**TYRONE TOWNSHIP PLANNING COMMISSION
REGULAR MEETING AGENDA
July 13, 2021 7:00 p.m.**

Planned Unit Development Parallel Plan Review for Tyrone Township, Michigan

Special Land Use and Site Plan Amendment Review for Tyrone Township, Michigan

PARALLEL SITE PLAN LAYOUT
LAKE URBAN ESTATES

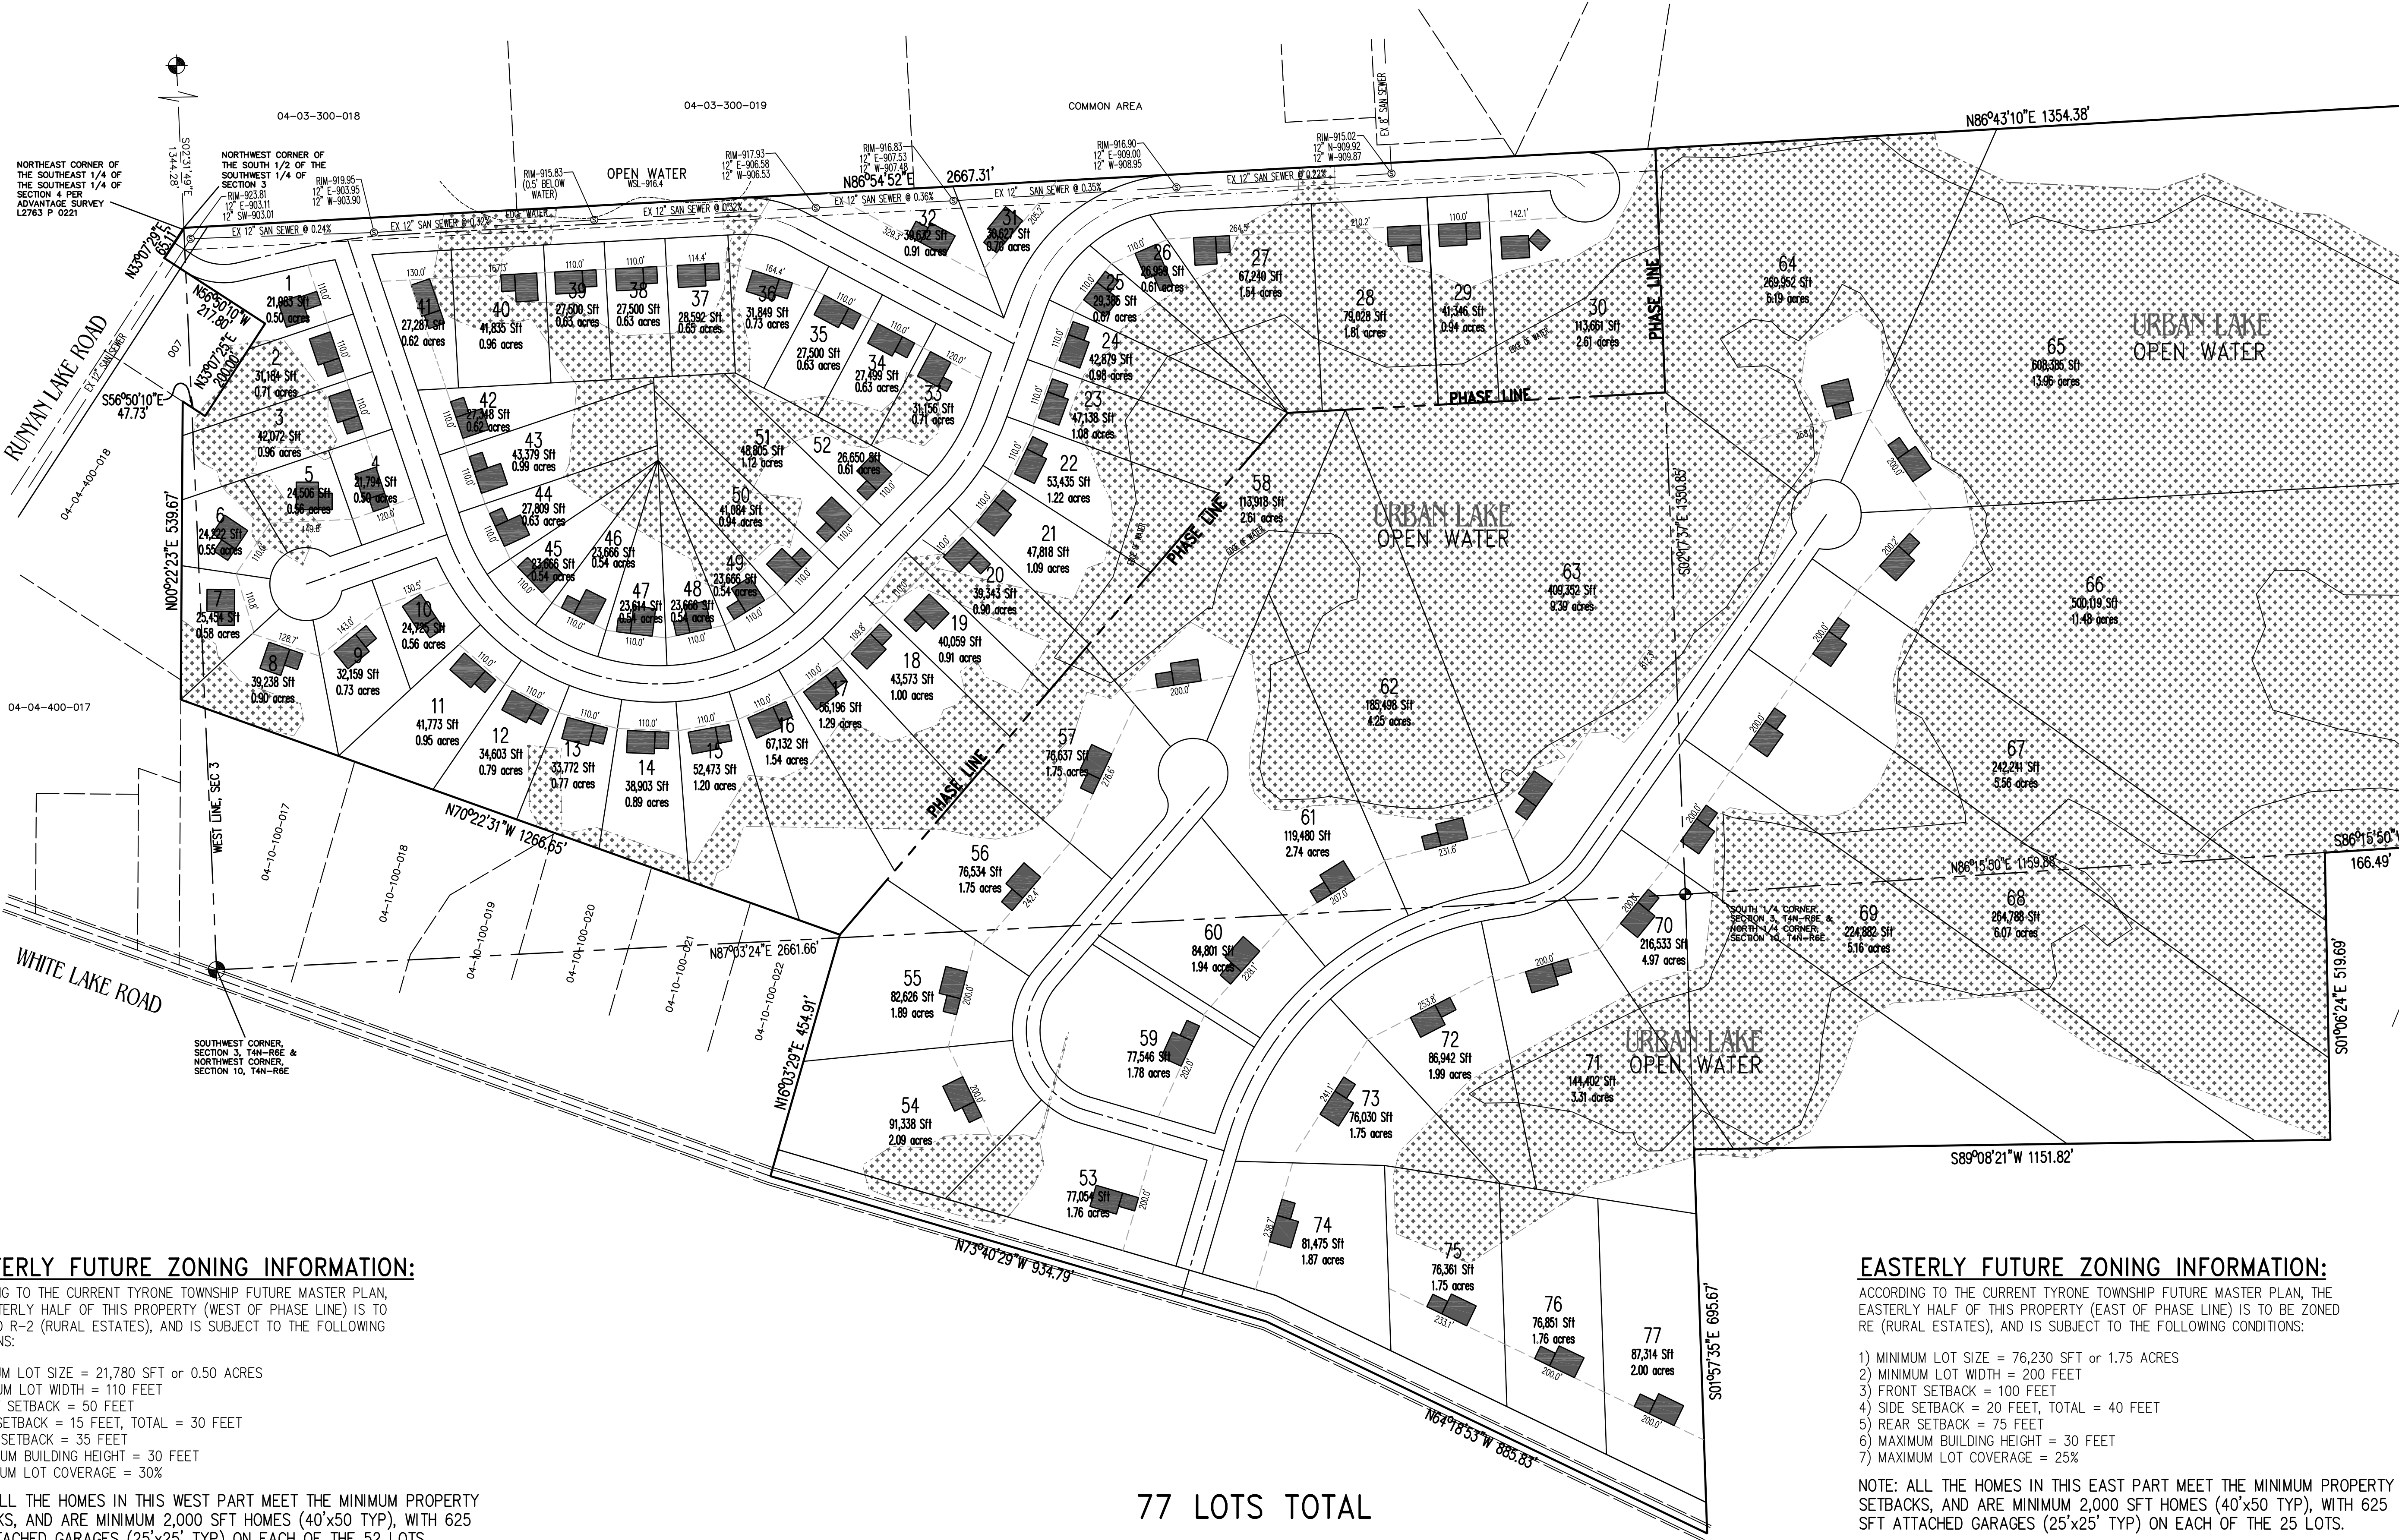
The boundary, as identified in the Future Land Use Map, is different from that used to prepare this parallel plan. The boundary in the Future Land Use Map runs roughly north and south from a property corner. The boundary in the parallel plan runs from that corner along the northern edge of Lake Urban, matching the phase boundary of the proposed development.

Although the parallel plan deviates from what is shown in the Future Land Use Map, it appears appropriate for the Planning Commission to consider use of the proposed boundary. It is common to use natural features as boundaries, and that practice has been used in other areas of the Future Land Use Map. At the last review, the Planning Commission appeared to be comfortable with this approach.

Comments: This revised parallel plan shows possible locations for a 2,500 square foot house and 2-car attached garage on each of the lots.

Comments: The proposed lots in the revised parallel appear to meet the developmental standards for the R-2 Single Family Residential district in the northwestern portion of the site and the RE Rural Estate district in the southeastern portion of the site.

Comments: *Although not dimensioned, it appears that the proposed road rights-of-way in the parallel plan would allow for the installation of roads generally consistent with design standards, including cul-de-sacs.*

Comments: *The parallel plan appears to provide adequate space for essential services.*

This parallel plan includes building footprints, showing the potential location for houses on each of the lots. Even with the extensive wetlands and a sanitary sewer easement, it appears that all of the lots appear feasible.

The Planning Commission should confirm if it is comfortable using the natural features as a boundary rather than the line identified in the Future Land Use Map. If not, the parallel plan should be revised consistent with the boundary as shown in the Future Land Use Map.

The Planning Commission should determine if any of the proposed lots in the parallel plan do not appear to be feasible.

Map 2- Future Land Use Map

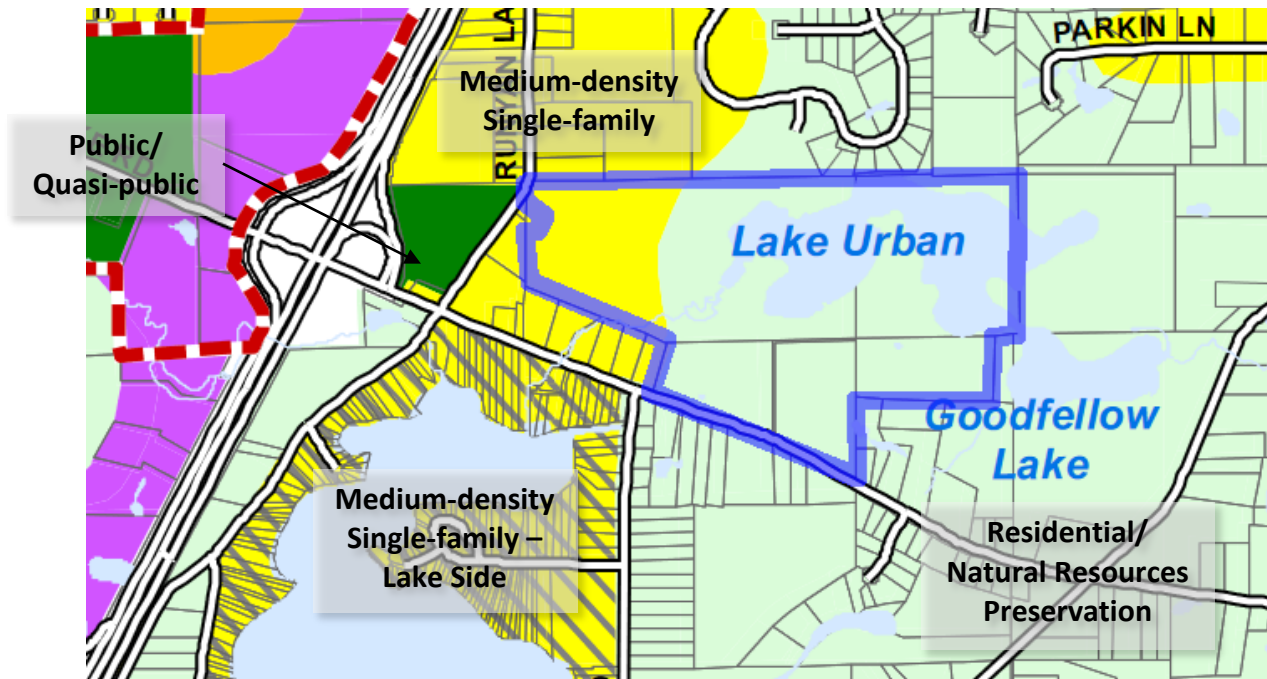
Comments: The boundary between the Medium-density Single-Family Residential and Residential/Natural Resources Preservation areas cuts through the property.

7079 OLD US HWY. 23
SITE PLAN
TYRONE TOWNSHIP, LIVINGSTON COUNTY, MICHIGAN
EXISTING CONDITIONS PLAN

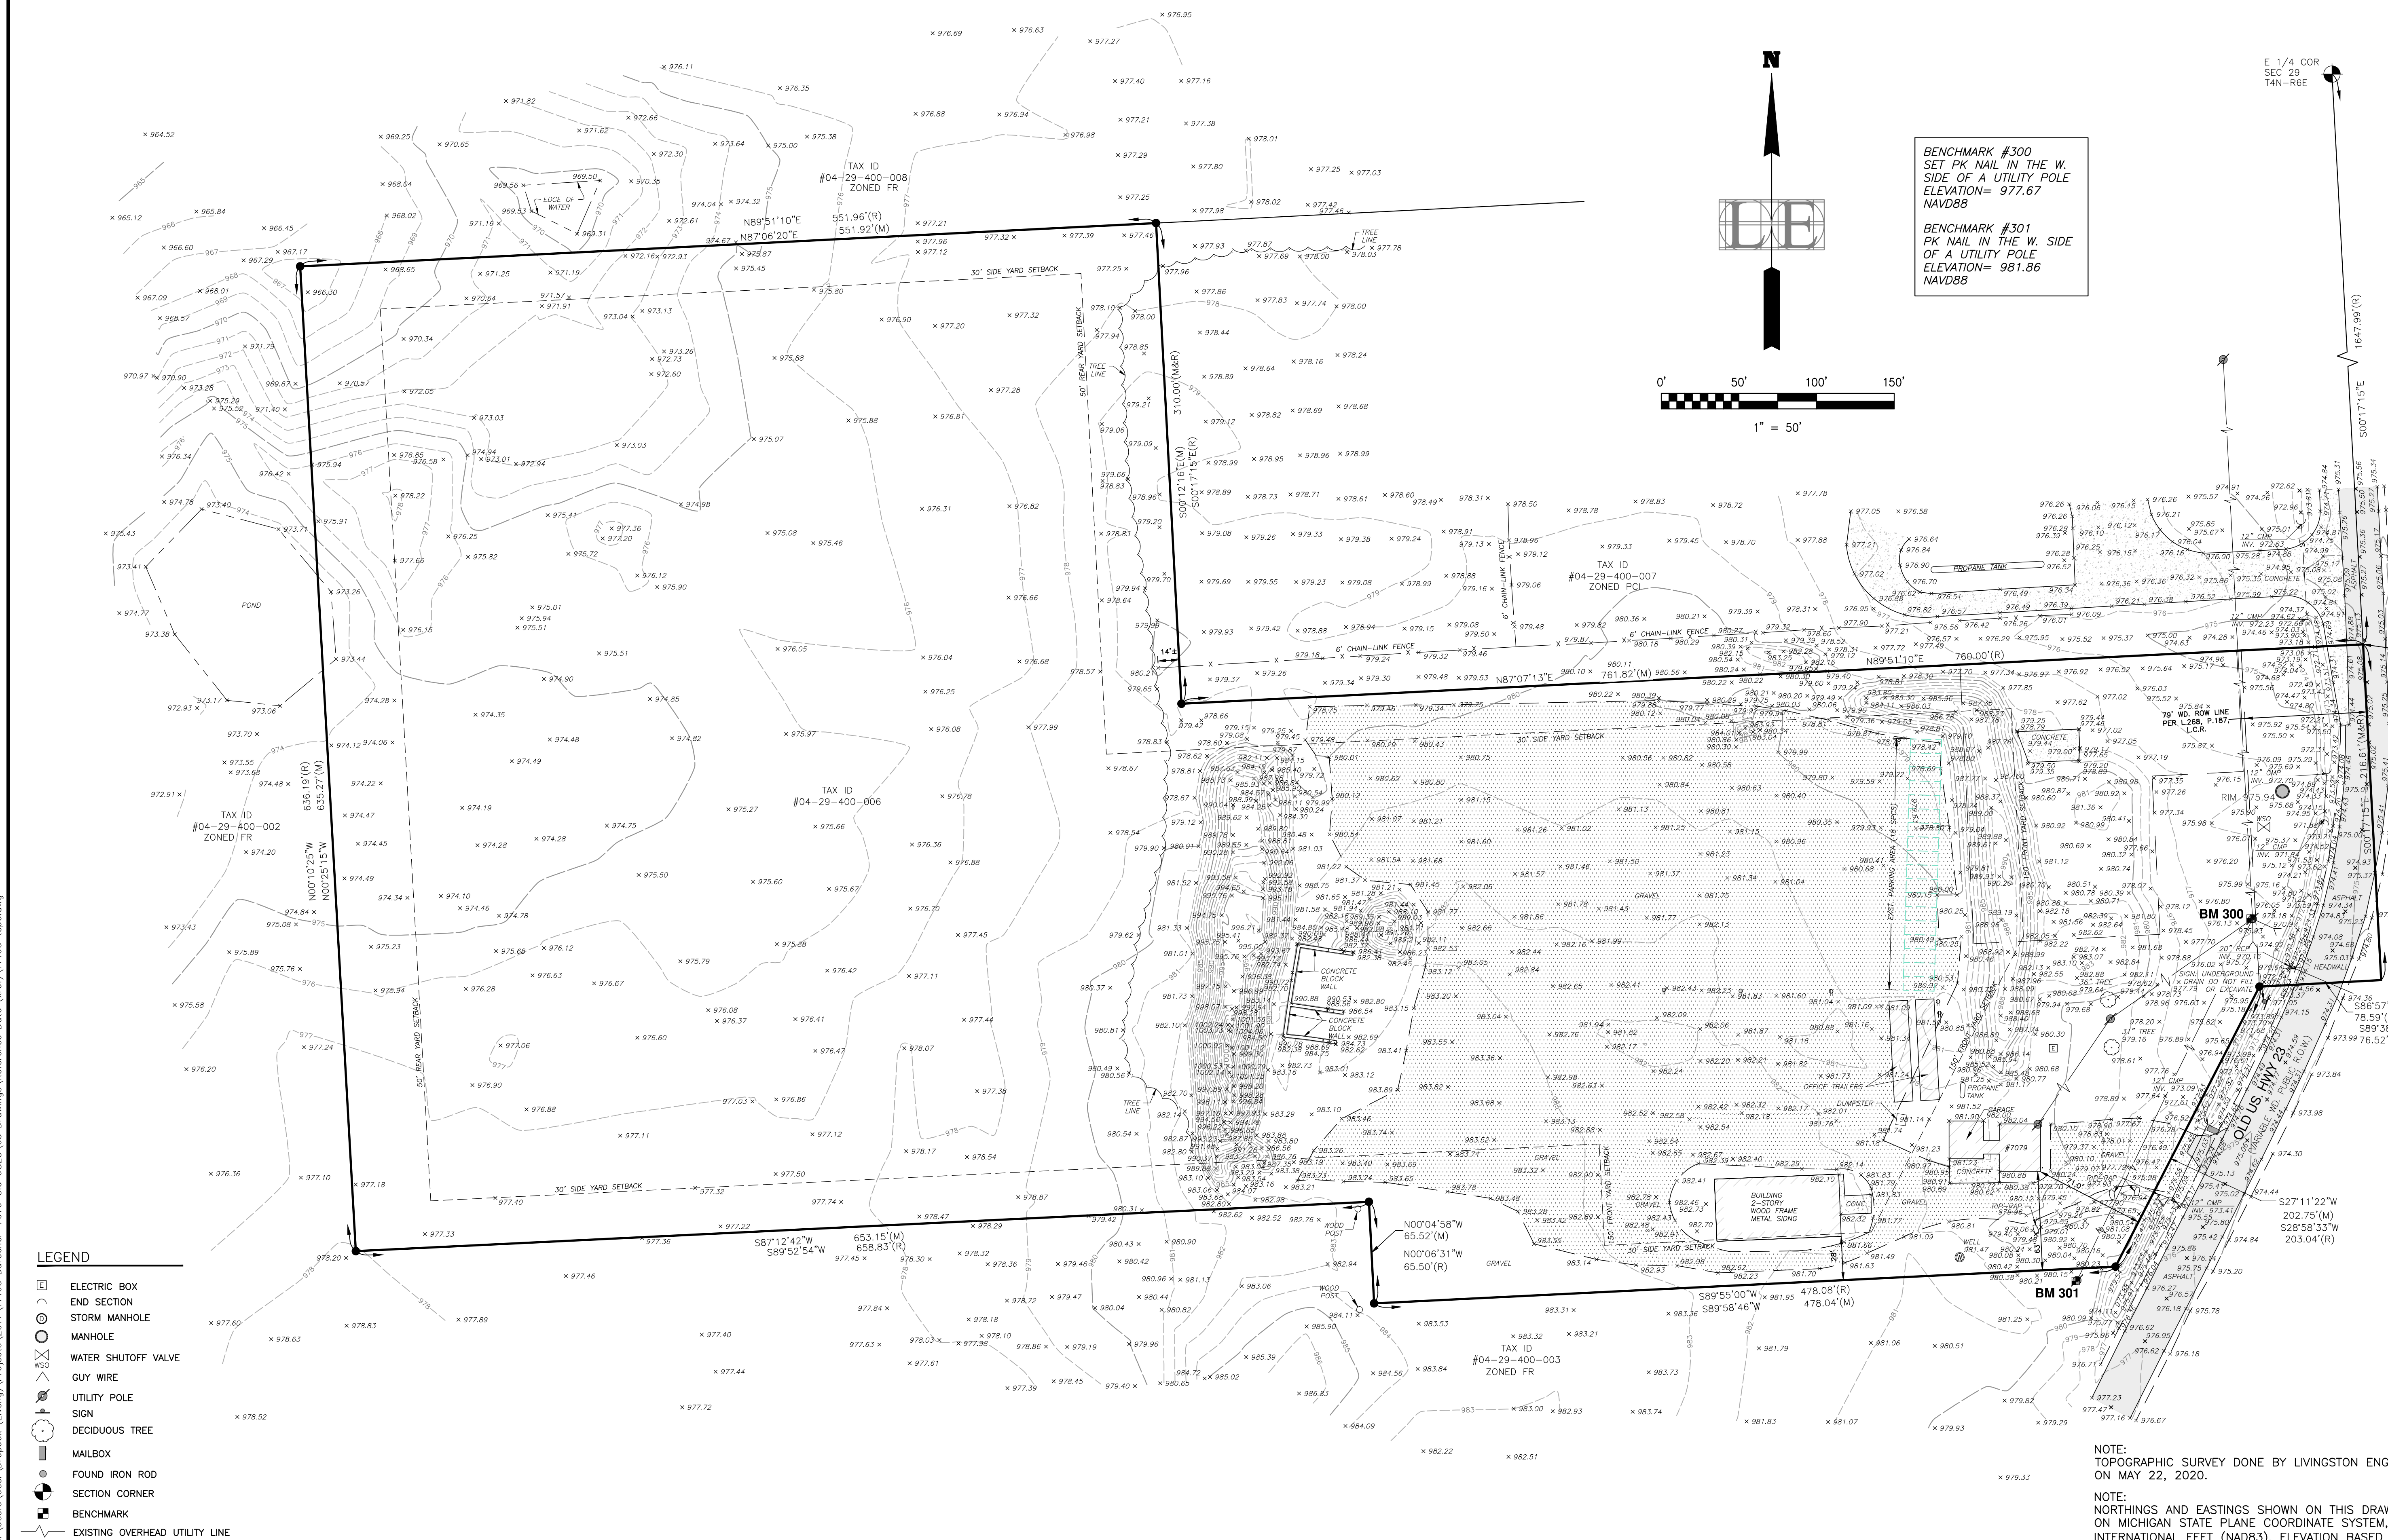
The site plan shows the location of 2 new stormwater management detention ponds. The pond in the front between the berm and Old US 23 appears to be located in an area that had an identified septic field and easement in the previously-approved site plan. If the septic field and easement are no longer in use or in place, the applicant should provide confirmation. If the septic field and easement are still in use or in place, this detention pond should be relocated.

The site plan is not clear what existing vegetation will be removed. If the existing vegetation between the lot lines and the required setbacks remains, it appears likely to provide adequate screening.

CWA Comment: *The site plan shows existing and proposed gravel areas, which could be used for storage areas, truck staging areas, and similar operations, extending into required side and rear yard setbacks. The existing gravel area along the northern lot was shown meeting the setback in the previously-approved site plan, but it has since extended into the setback. It appears that the expansion area will extend into all of the required yards.*

There are several areas where the proposed surface improvements, which could be used for staging and parking, are located within required side and rear yards, as noted above. The site plan should be amended so that these areas meet the required setbacks.

There is a discrepancy between the hours of operation noted on the cover sheet. It is described as 6:30 am to 6 pm under Site and Use Notes and 7 am to 6 pm under Site Plan Notes. This should be corrected.

Items to be Addressed: 1) The location of the existing propane tank should be added to the site plan. 2) The detention pond along Old US 23 should be relocated unless the applicant provides confirmation of abandonment of the septic field and easement. 3) The Planning Commission should consider requesting the applicant demonstrate it would be possible to manage stormwater if the entire site is paved in the future. 4) Township Engineer approval of the stormwater management.

The site plan should be amended for the open storage yard, equipment storage areas, truck staging areas, and similar operations to meet the required setbacks.
